Section 96(2) Development Application Statement of Environmental Effects

161 Sussex Street, Sydney

Section 96(2) Modification - SSD-4972

Submitted to Planning and Infrastructure

Figure 1 – Through Site Link
Source: Cox Richardson

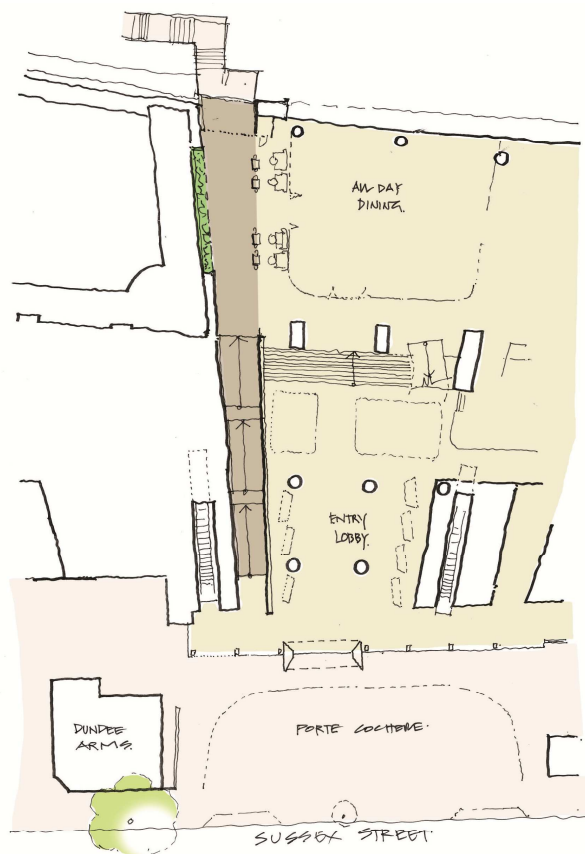
Amendments are proposed to the approved through site link that passes through the centre of the hotel and connects Sussex Street to Wheat Road. The proposed amendments are shown in drawing A-DA-0201 at **Appendix A** and illustrated in **Figure 1**. They involve:

- Demolishing and replacing the existing stairs connecting the site with Wheat Road. New stairs will provide more direct access;
- Providing a more generous landing space at the top of the stairs adjacent to the hotel entrance;
- Removing the stairs within the approved internal walkway and replacing them with a series of ramps to provide equitable access; and
- Reconfiguring the internal hotel space to allow for a more open, active and engaging environment along the walkway. Specifically, converting the ground level meeting rooms to a new open internal dining area overlooking the through site link.

Figure 2 – Slip Street (Approved vs Proposed)
Source: Cox Richardson

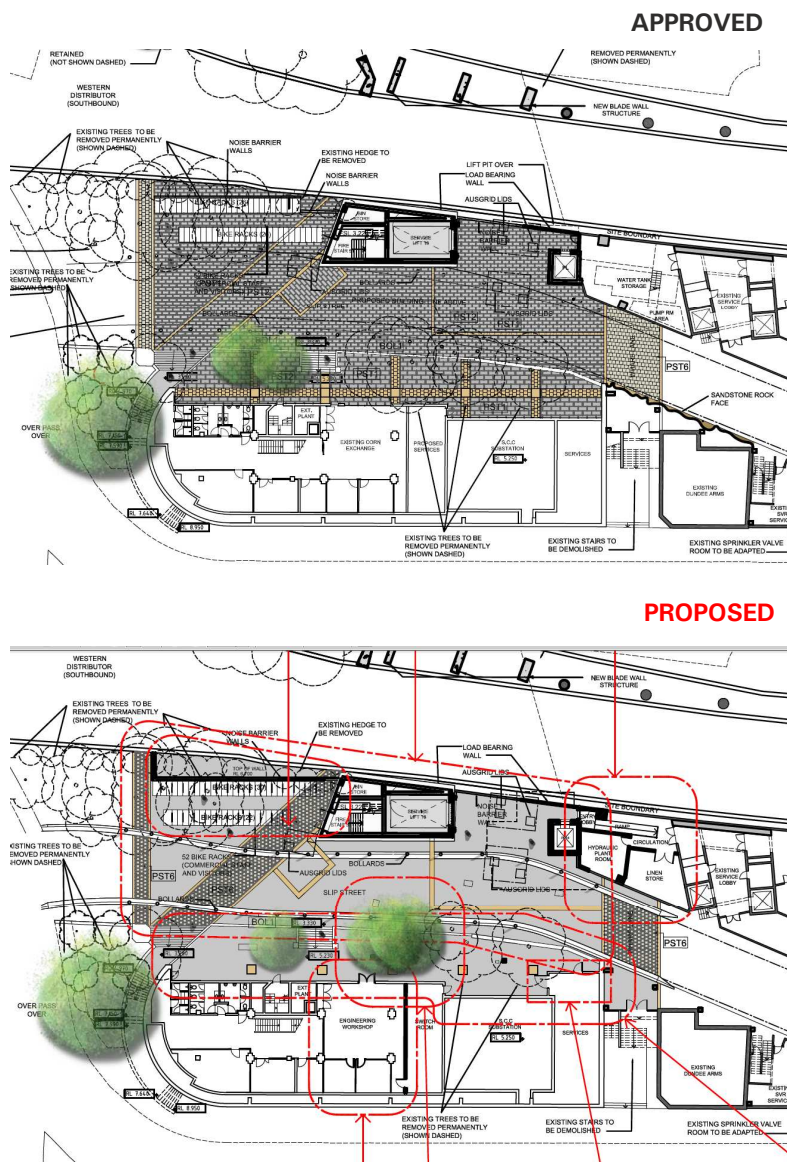
A series of minor amendments are proposed to the public domain along the Slip Street. These are largely in response to further detailed design development and reflect hotel operational requirements and the logistical needs of the development. The changes also reflect the Public Domain Plan prepared in accordance with the conditions of approval for the development (provided for information only at **Appendix C**). The proposed amendments are shown in **Figure 2** and involve the following.

The previous fully paved road treatment is to be replaced with a combination of bitumen and cobblestone/pavers (see drawings at **Appendix C**). Bitumen is considered a more suitable material to withstand the effects of the trucks and delivery vehicles that use Slip Street. In addition, the high number of service pits on Slip Street necessitates the use of bitumen. Cobblestones will be used to delineate and indicate historic roads and the like.

The approved bicycle racks and noise barrier are proposed to be reconfigured to provide a more functional layout for bicycle storage, and the approved Class 2 bicycle storage facilities are to be replaced with Class 3 bicycle rails to accommodate 52 bicycles (in accordance with Condition C8 of the determination).

- extensions to the existing Switch Room to meet AusGrid requirements, with the 15sqm extension will be contained under the existing colonnade and rendered and painted to match the adjacent existing finish; and
- inclusion of an engineering/ maintenance office for the hotel (internally within existing footprint).

Figure 5 – Porte Cochere and Northern Courtyard (Approved vs Proposed)
 Source: Cox Richardson

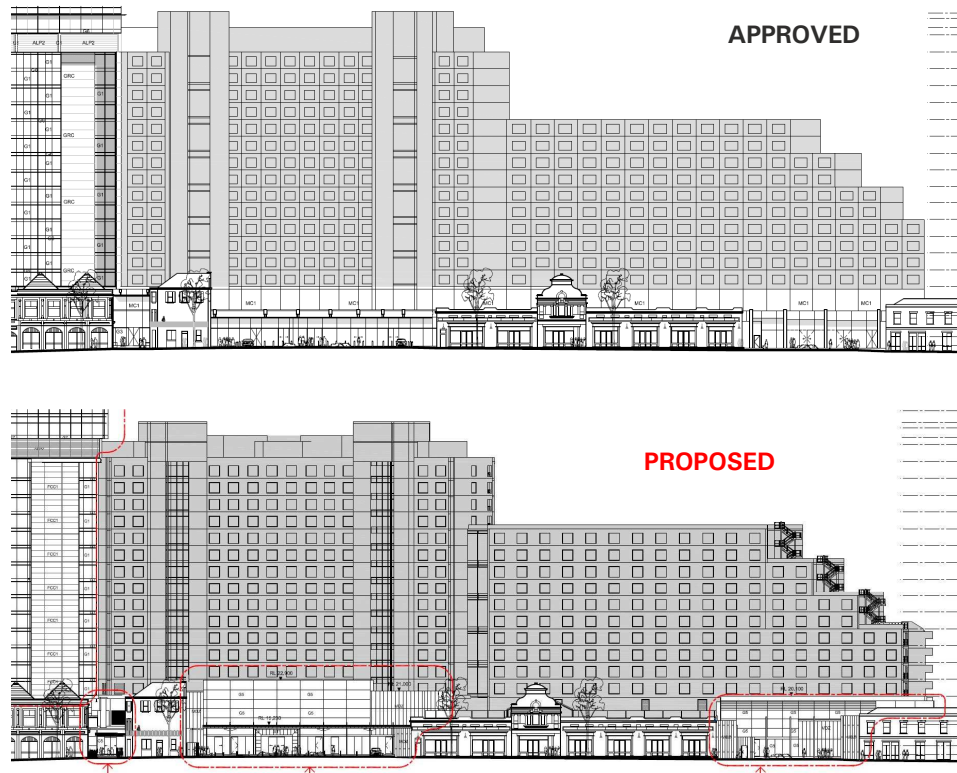
Changes are proposed to the approved design of the Sussex Street porte cochere and involve:

- Changes to the building lobby entrance and façade, including a new double height glazed frontage to the porte cochere and Sussex Street;
- Minor design changes to the glazed building awning;
- Re-instating and recladding the existing exhaust shafts from Slip Street which were shown to be removed under the approved development; and
- Incorporating a new sprinkler valve room and fire services cupboard.

A number of minor changes are proposed to the building's secondary (northern) entrance along Sussex Street – to become the Northern Courtyard, including:

- Changing the function of the entry to become an emergency egress point only and convert the space to outdoor seating for the adjacent Northern Warehouse;
- Replacement of the awning with a new double height glass structure that matches the proposed design of the building's main porte cochere;
- Reinstatement of the exhaust shafts along Sussex Street (which were proposed for deletion under the approved scheme); and

- Increasing to the size of the Fire Control Room.

The changes to the porte cochere and northern courtyard entrance are shown in **Figure 5** below.

Figure 6 – East Tower Elevation (Sussex Street)
Source: Cox Richardson

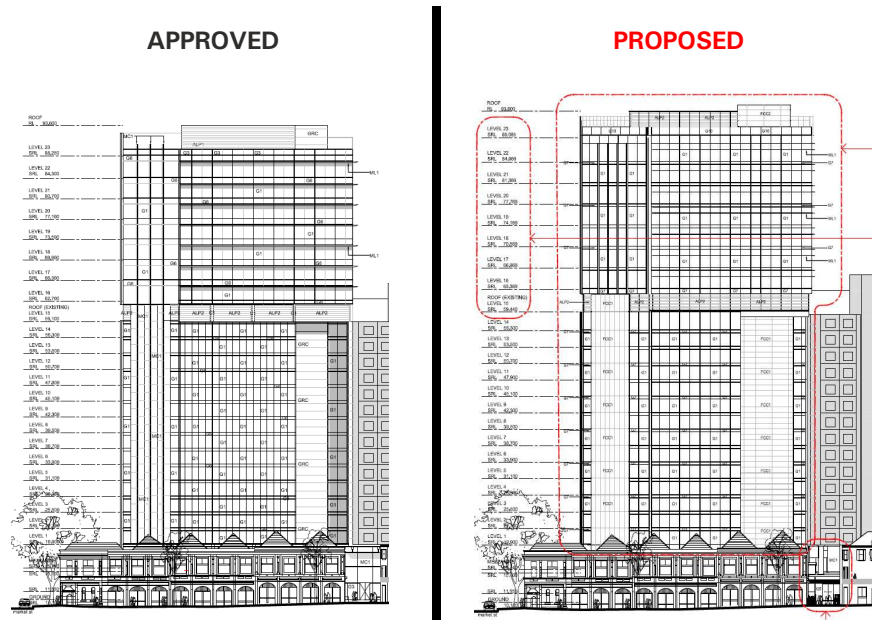
A number of modifications are proposed to the external design of the approved tower (see **Figures 6, 7 & 8**), principally involving amendments to the materials and sunshade treatments used for the tower's façade, specifically:

- The use of Equitone panelling instead of glass fibre-reinforced concrete cladding on the north, south and east elevations;
- Re-orientation of the approved metal sunshade devices from vertical to horizontal. This change principally relates to the southern and western elevations;
- Replacement of composite aluminium panelling with Equitone panelling along the building's eastern and northern elevations;
- Replacement of performance wall glass with 'balustrade to curtain wall glazing' where balconies are deleted.

Figure 9 – Function Building Western Façade (Proposed)
Source: Cox Richardson

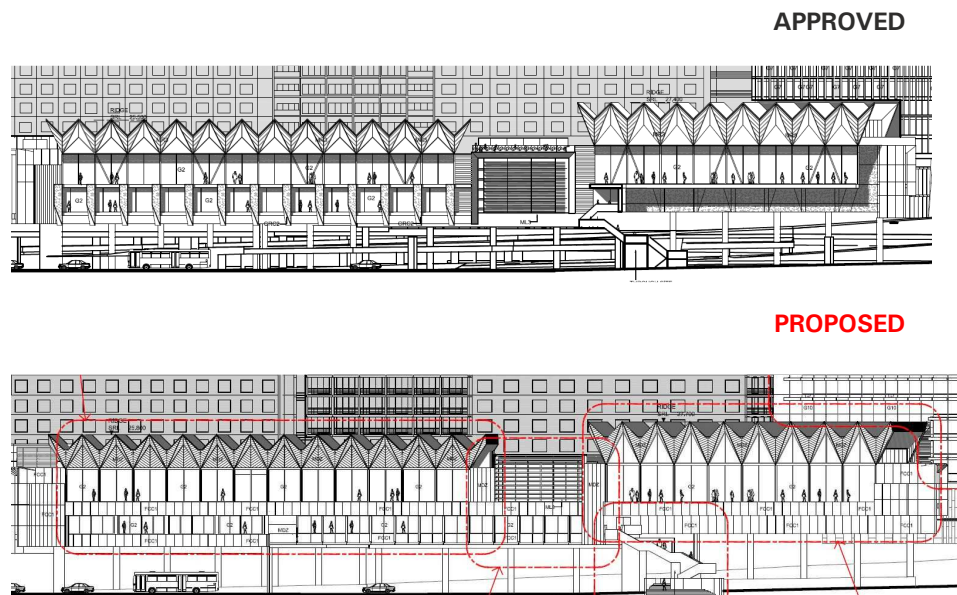
A number of modifications are proposed to the facade of the approved function and conference extension (see **Figure 9**), these include:

- Changes to the extent and location of glazing on the western façade..
- The introduction of zinc cladding along the western façade to offset the glazing and emphasise the feature sawtooth roof.
- The introduction of Equitone panelling instead of glass fibre-reinforced concrete cladding.
- A minor variation to the design and treatment of the building parapet along the sawtooth roof.
- Revisions to the design of the central pre-function façade including changes to louvres, materials and rooftop design.
- A 300mm increase in the height of the sawtooth roof ridgeline of the northern function hall from RL25.50 to RL25.80, and the that of the southern function hall from RL27.40 to RL27.70.
- Changes to the design and simplification of the through site link stairs to Wheat Road.

A comparison between the approved and proposed design is provided in **Figure 9**, with further details provided in the Architectural drawings included at **Appendix A**.

Figure 13 – View of Through Site Link from Hotel Foyer
Source: Cox Richardson

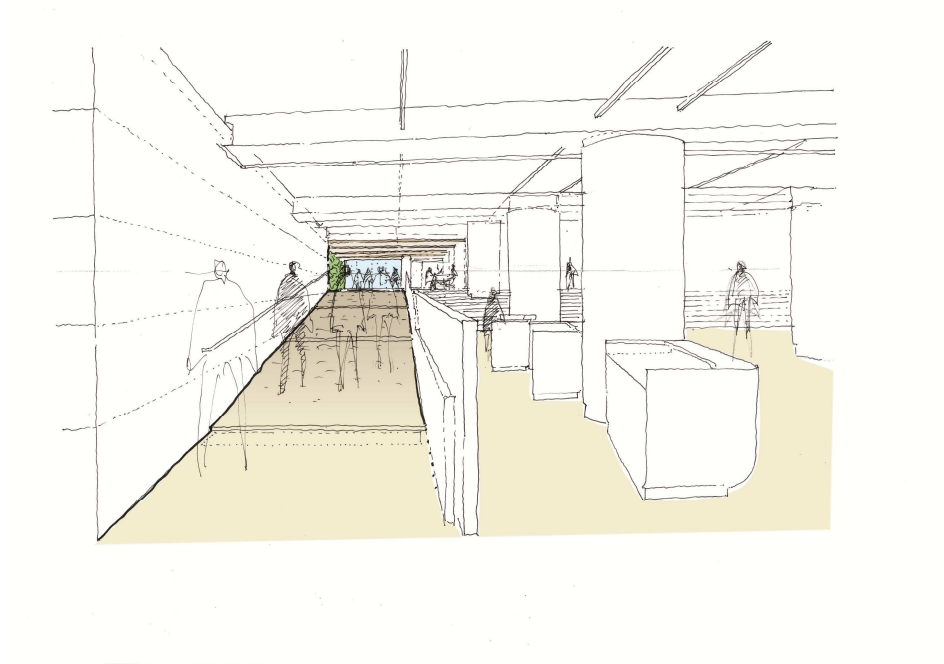
Following determination of the SSD application, further consultation with RMS identified that the inclusion of a lift and escalator pit over the Western Distributor was not feasible given that it would not achieve the necessary clearance over the motorway. Further design development was therefore undertaken to provide a ramped link which better integrates with the hotel environment.

As shown in the sketch at **Figure 13**, the revised design now allows for the link to be 'opened up', particularly at the western end facing Darling Harbour, and facilitates improved interaction between hotel guests and passers-by as a result of the relocated all-day dining area (see sketch at Figure ??). The proposed amendments also facilitate a safer and more welcoming environment as the western end of the link is no longer isolated by the dividing wall that previously separated the hotel from the Wheat Road entrance.

In addition the amended design allows for equitable access within the hotel where previously stairs at the eastern Slip Street entrance necessitated use of the internal lift to get from the eastern to the western end of the building. The amended design therefore significantly improves accessibility within the building.
